**DECISION NOTICE UNDER S 335 SUSTAINABLE PLANNING ACT 2009:
DEVELOPMENT APPLICATION FOR 2L OASIS DRIVE, WONGA**

Reconfiguring a Lot (1 Lot into 17 Lots)

Drawing or Document	Reference	Date
Proposal Plan	Flanagan Consulting Group, Sketch 3969-SK03 dated 3 December 2014 and to be amended by the conditions of the approval.	To be determined.
Water Reticulation Plan	Flanagan Consulting Group, Sketch 3969-SK04, as submitted to Council on 10 December 2014 and to be amended by the conditions of the approval.	To be determined.
Stormwater Drainage Plan	Flanagan Consulting Group, Sketch 3969-SK05 as submitted to Council on 10 December 2014 and to be amended by the conditions of the approval.	To be determined.
Drainage Details / Earthworks Plan	Flanagan Consulting Group, Sketch 3969-SK06 as submitted to Council on 10 December 2014 and to be amended by the conditions of the approval.	To be determined.
Marlin Drive Turnaround	Flanagan Consulting Group, Sketch 3969-SK07 as submitted to Council on 10 December 2014 and to be amended by the conditions of the approval.	To be determined.

3969-SK03 1:1000
 A1 Full Size
 Acad No. 3969-SK03 9 December 2014

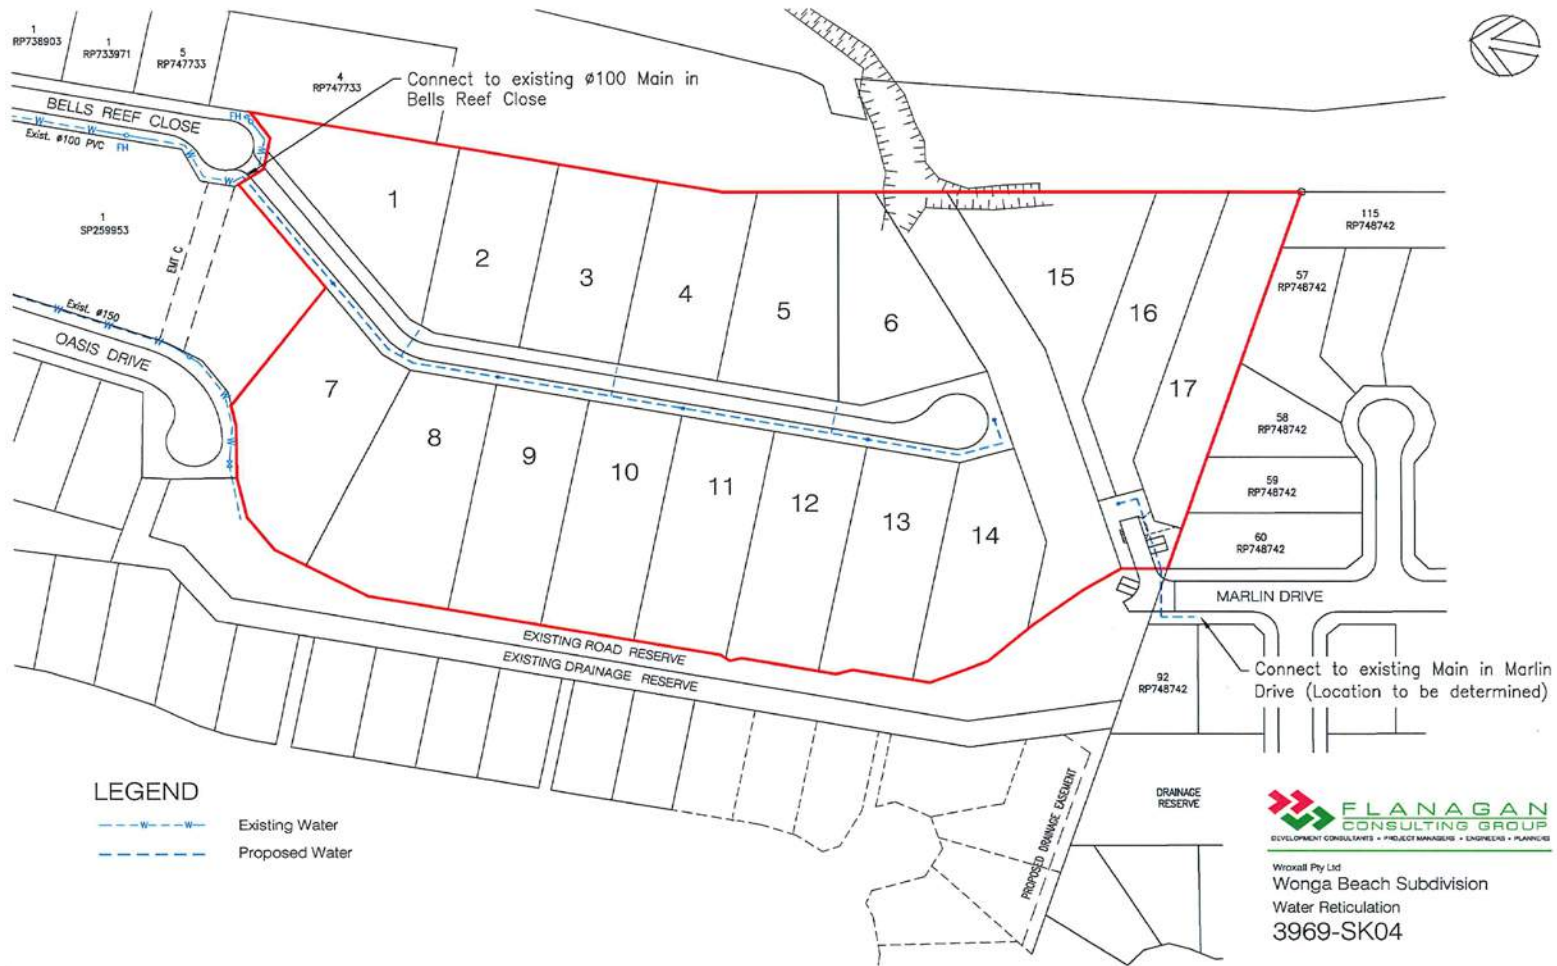
4. The street layout and design is to be generally in accordance with Flanagan Consulting Group (FCG) Proposal Plan, Sketch 3969-SK03 subject to:
 - a. Deletion of the catch drain and easement at the eastern boundary of Lots 1-6 and Lots 15-17 inclusive;

- b. Setback of fill areas a minimum of six (6) metres from the property boundary from all roads and Esplanade.
 - c. Setback of fill areas a minimum of three (3) metres from the southern boundary of proposed Lot 17.

- d. The fill pad for proposed Lot 7 is to be extended to the northern boundary and retained;
 - e. The fill pad for Lots 1 to 6 inclusive must be a continual plane with the pads draining to the new road to the west.

- f. The fill pad for Lots 7 to 14 inclusive must be a continual plane with the pads draining to the new road to the east. The rear of these lots is to be graded to the west to negate ponding of water between the fill pad and the existing road reserve;

- g. The fill pad for Lots 15 to 17 inclusive to be a continual plane with the pads draining to the new drainage reserve
 - h. On-street car parking spaces in the vicinity of lots 15 to 17 are to be provided as shown on FCG Sketches 3969-SK03 to 06 and the maintenance access to the new drainage reserve are to be designed with minimal increase of stormwater drainage to Marlin Drive.

Woxall Pty Ltd
 Wonga Beach Subdivision
 Water Reticulation
 3969-SK04

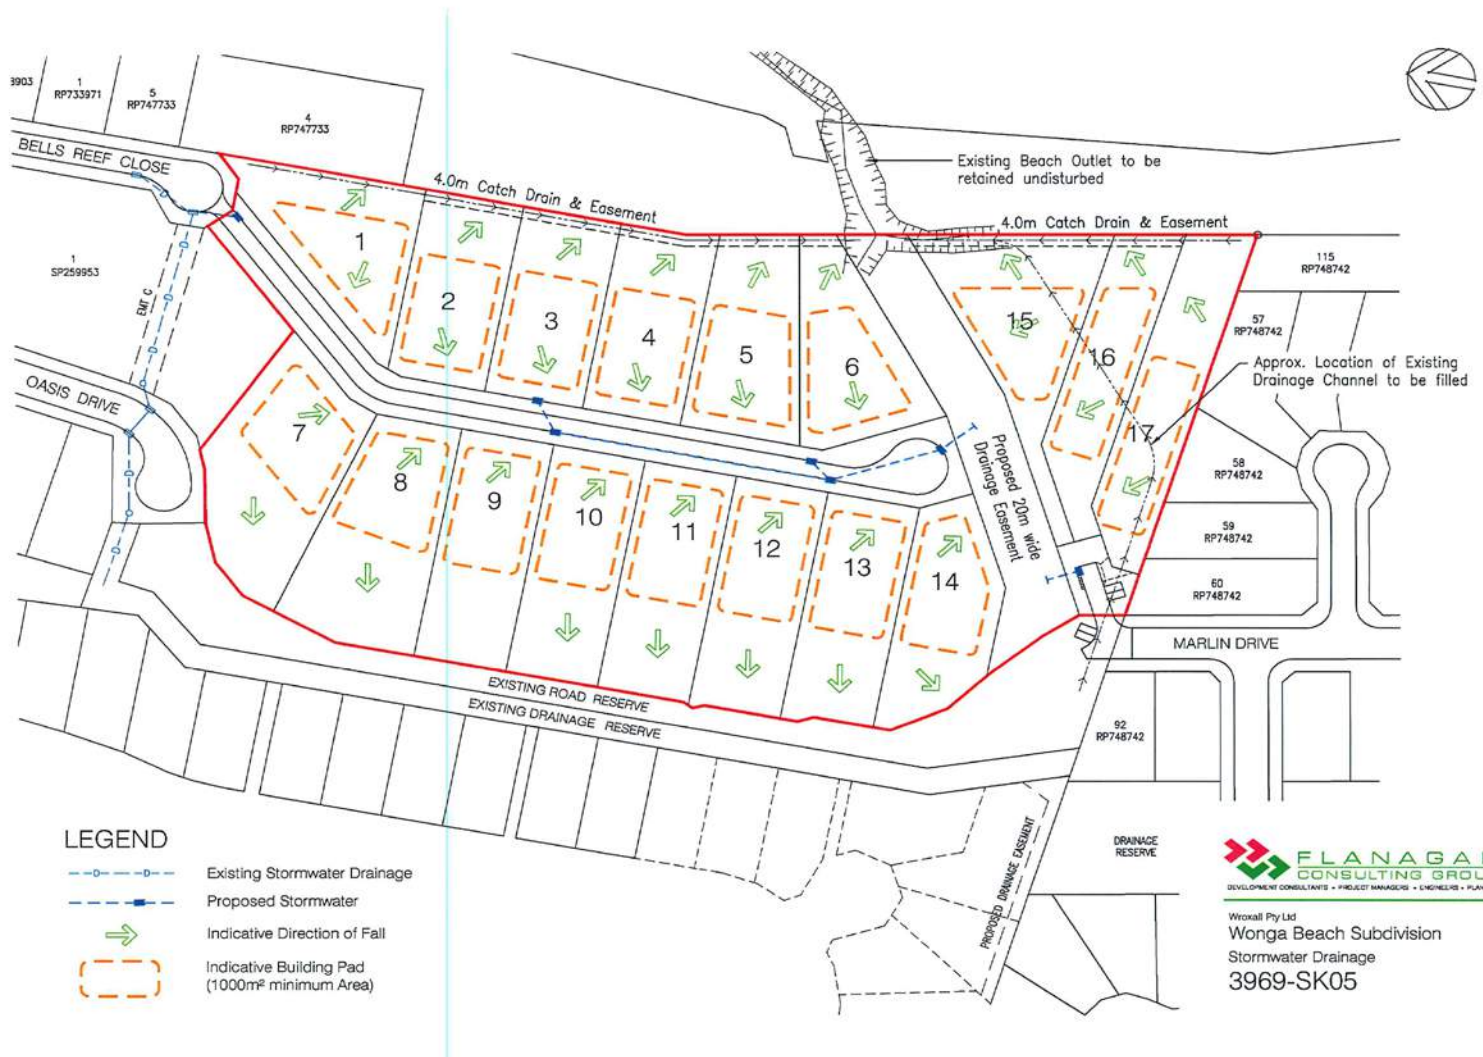
- 5. Undertake water supply works internal to the subject land in accordance with the *FNQROC Development Manual* within the internal road system such that each lot can be connected to Council's water supply network at the lot frontage. A plan of the water supply reticulation network is to be generally in accordance with FCG Sketch 3969-SK04 and must be supported by appropriate calculations including hydraulic network analysis demonstrating compliance with the *FNQROC Development Manual*. In particular, the plan must include:

- a. A minimum 100mm main on one side and a 50mm (63mm OD) main on the opposite side to provide a looped service;
 - b. A minimum 100mm connection from the southern end of the cul-de-sac to the northern end of Marlin Drive;

- c. Provide the conduit for water supply for the full length of the access leg for proposed Lots 15 and 16. The conduit does not need to be connected to Council's water supply. The conduit must be capped and staked at the road frontage of the lots and at the end of the access leg for easy identification when a future house is constructed on this lot;

The plan must also identify any infrastructure external to the subdivision that may require upgrading to accommodate the development and achieve the minimum pressures for maximum hour and firefighting scenarios.

Woxall Pty Ltd
 Wonga Beach Subdivision
 Stormwater Drainage
 3969-SK05

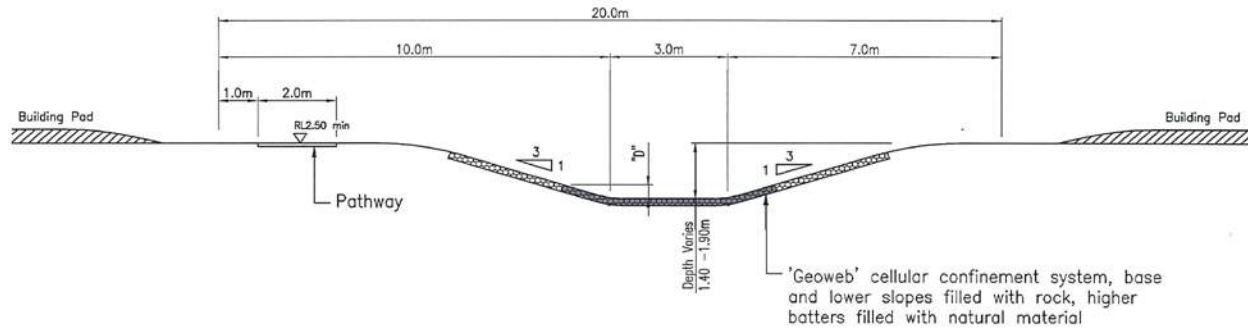
10. The concept for excavation and earthworks as detailed on FCG Sketch 3969-SK05 and SK06 is generally approved subject to compliance with the on-site disposal and drainage conditions and subject to the following amendments:

- a. The earthworks fill zones are to be continuous across the boundaries of lots to avoid localised low points between properties;
 - b. The rear of allotments are to be graded evenly in accordance with the concepts shown on FCG Sketch 3969-SK05 to ensure that they remain free draining throughout the property and through to the drainage reserve or Esplanade area.

- c. The nominated fill level of 2.9m is to be increased to 4.04 metres AHD level unless otherwise approved by Council. Any reduction below 4.04 metres AHD must be supported by a further study, to the satisfaction of Council, to a lower level than 4.04 but no lower than 3.54 metres AHD. Any reduction below 4.04 metres AHD must utilise at least a 0.3 Sea Level Rise (SLR) and increase in intensity of cyclone action.

19. The subject land must be drained to the satisfaction of the Chief Executive Officer generally in accordance with FCG sketch 3969-SK05. In particular:

- iii. The design of the SQIDs shall not compromise the hydraulic performance of the overall drainage system.
- iv. SQIDs shall be positioned so as to provide appropriate access for maintenance equipment.
- c. All new allotments shall have immunity from flooding associated with an ARI 100 year rainfall event; and
- d. Where practical, all new allotments must be drained to the road frontages, drainage easements or drainage reserves and discharged to the existing drainage system via storm water quality device(s). Note the drainage easement shown on FCG Sketch 3969-SK05 in the eastern side of Lots 2 to 6, 15 and 16 is not required.

Woxall Pty Ltd
 Wonga Beach Subdivision
 Drainage Details / Earthworks Pad
 3969-SK06

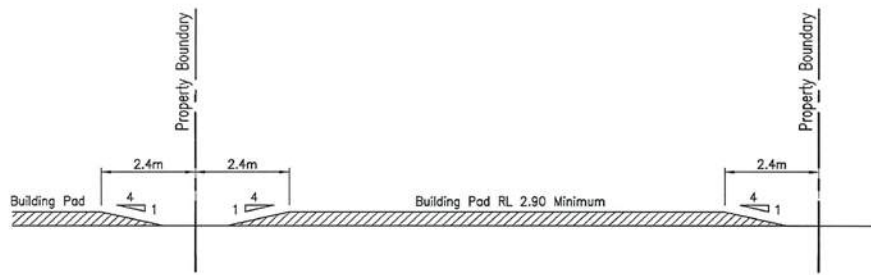
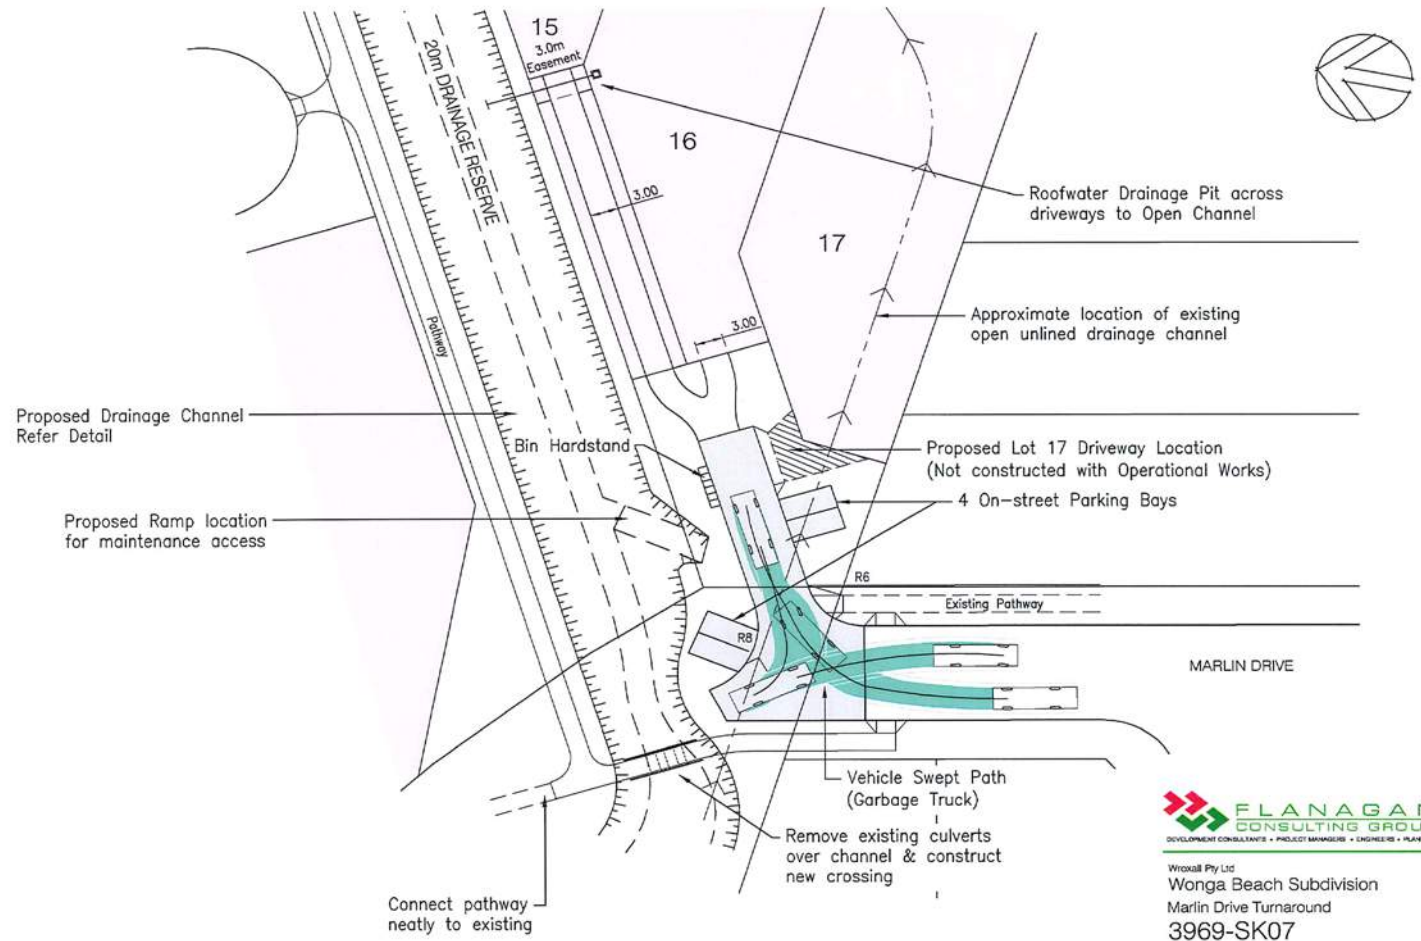
17. The applicant / owner must undertake the development of the land in accordance with the findings of the Drainage Study dated 28 November 2013 prepared by DHI Water and Environment Pty Ltd as detailed by FCG Sketch 3969-SK05 and SK06 with a robust channel base lining to facilitate trafficability and maintenance to the satisfaction of the Chief Executive Officer.
